COA (SP) 2017-001
February 16, 2017

**STAFF REPORT
SPECIAL CERTIFICATE OF APPROPRIATENESS
FOR THE PROPERTY AT
4125 SANTA MARIA STREET
A CONTRIBUTING RESOURCE WITHIN
“THE SANTA MARIA STREET” HISTORIC DISTRICT**

Proposal: The application requests design approval for additions and alterations to the residence and sitework. Variances have also been requested from Article 4, Section 4-101 (D) (4) and (5), Article 5, Section 5-108 (D) and Article 4, Section 4-101 (D) (9) of the Coral Gables Zoning Code for minimum side setbacks and maximum floor area ratio.

Front (west) Façade – ca. 1940s [top]; 2014 [bottom]

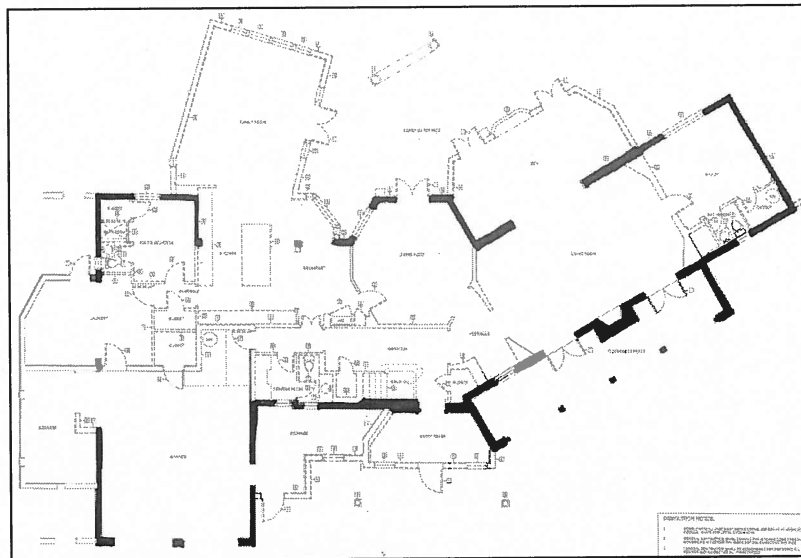
On the primary (west) elevation facing Santa Maria, the application proposes to remove the existing porte cochere and entry foyer and return the front entrance to its original location. The removal of the porte cochere will allow a blocked-up third window on the second floor to be returned. A storage area to the north of the garage will be converted to an open workshop and the storage area to the south of the garage will be removed entirely. It will be replaced high brick wall to match what was originally there creating a small enclosed courtyard off the proposed dining room. It will be accessed by two new French doors. On the second floor an addition is proposed to the north side of the residence. It extends the existing roofline and has no
